Peer Review Report

Osisko Canadian Malartic Project

**Golder Report – Evaluation du Débit d'Exhaure et des
Impacts Potentiels sur des Niveaux des Eaux Souterraines.
Osisko Exploration Malartic
Malartic, Québec**

**Re: — Peer Review – Golder Report
Evaluation de Débit d'Exhaure et des Impacts Potentiels
Sur les Niveaux des Eaux Souterraines, Osisko Exploration Malartic,
Malartic, Québec**

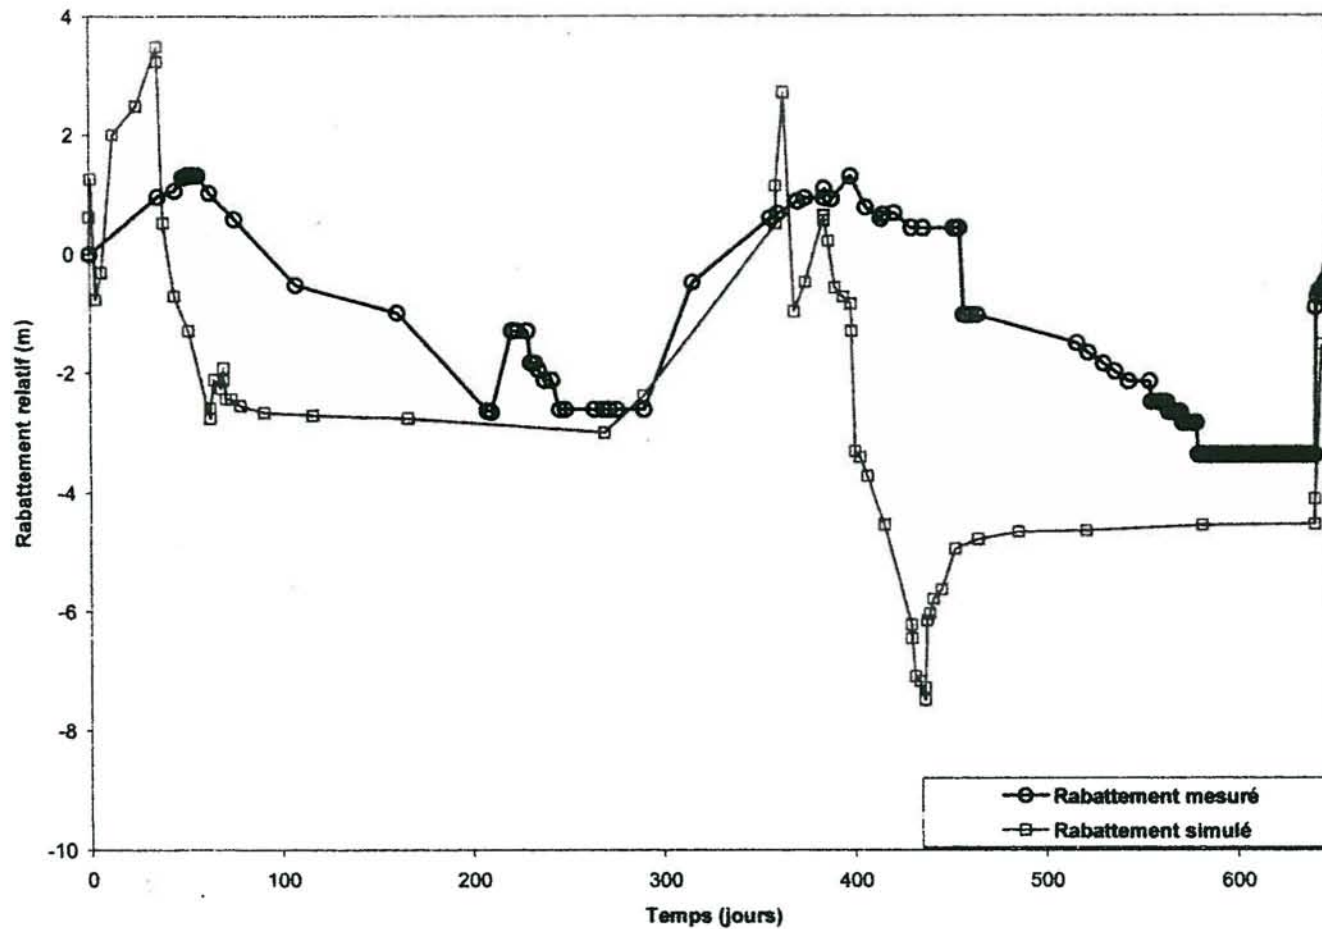
The pumping rate for one pump in the East Malartic shaft was set at 180m³/hr. and 360m³/hr. for 2 pumps. Figure 20 of the Golder report (included on page 8a) shows a graph of observed and simulated drawdowns for the period April 2006 to December 2007. The simulation overestimated the rate of drawdown but was reasonable approximation of the pumping rate for one pump only.

PROJET EVALUATION DU DÉBIT D'EXHAURE ET DES IMPACTS POTENTIELS SUR LES NIVEAUX DES EAUX SOUTERRAINES, OSISKO EXPLORATION, MALARTIC, QUÉBEC, CANADA
TITRE Graphique des valeurs de débits d'exhaure estimés selon les différents scénarios de simulations prédictive
PROJET No 07-1221-0028
FIGURE No 24

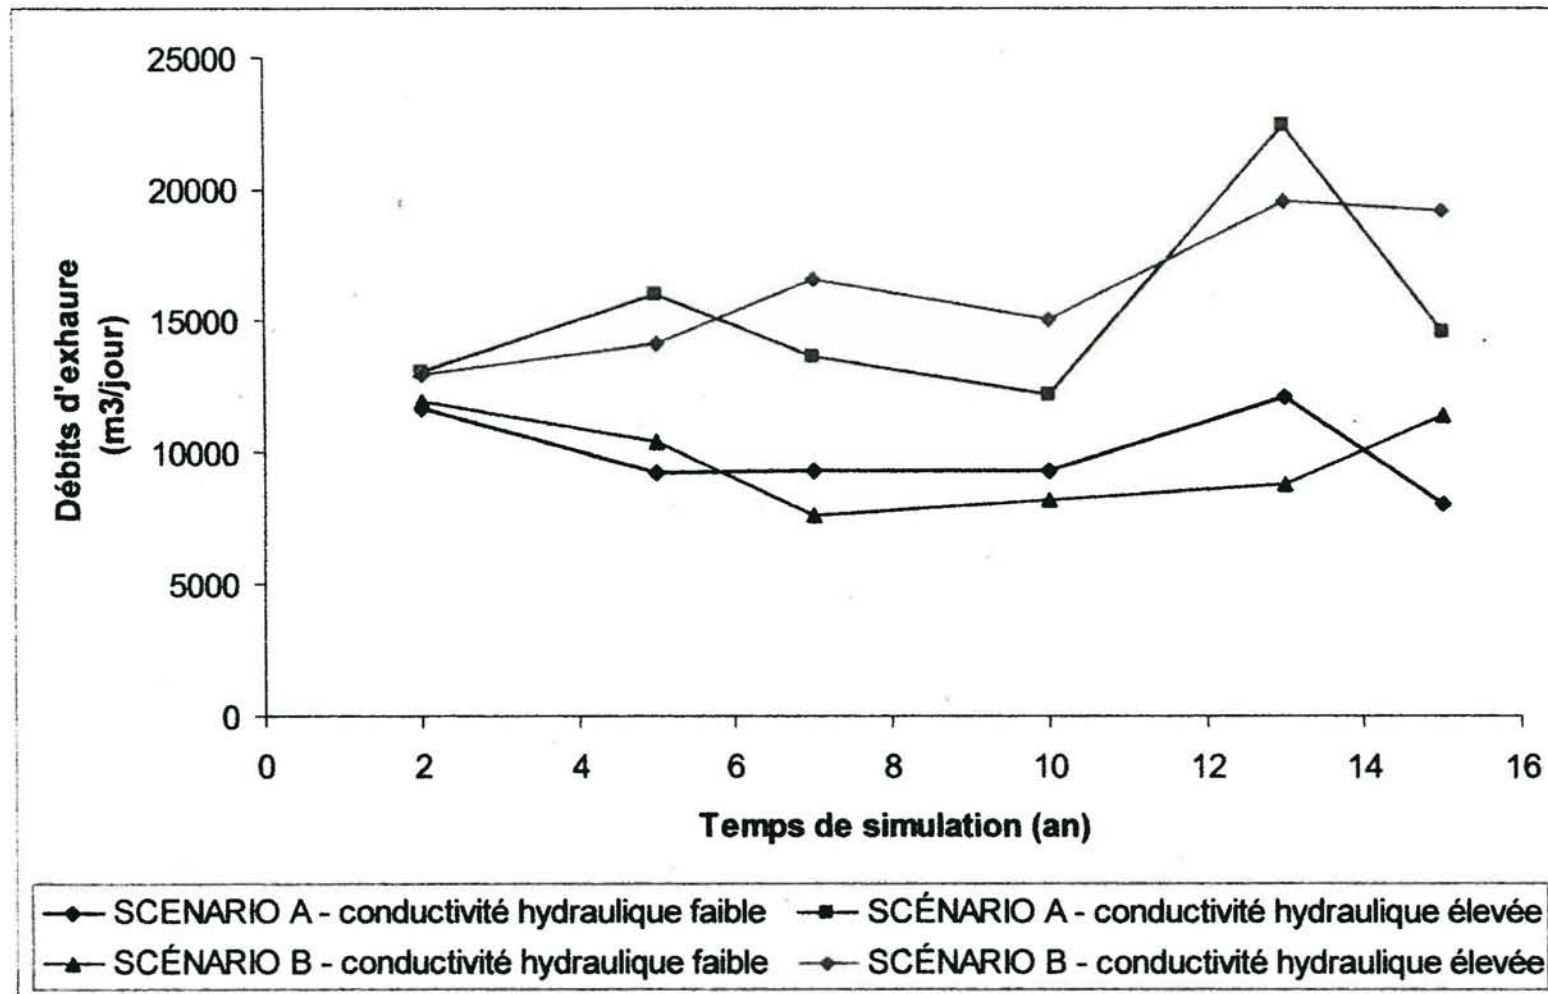
Table 13 (Golder – included on page 9) and Figure 21 (Golder – included on page 9a) show the estimated drainage rate values for the simulation. The total rate includes infiltration into the pit and underground and dewatering of the underground. It does not include runoff, direct precipitation and evaporation. The minimum rate simulated is 7,300m³/day and the maximum is 22,500m³/day.
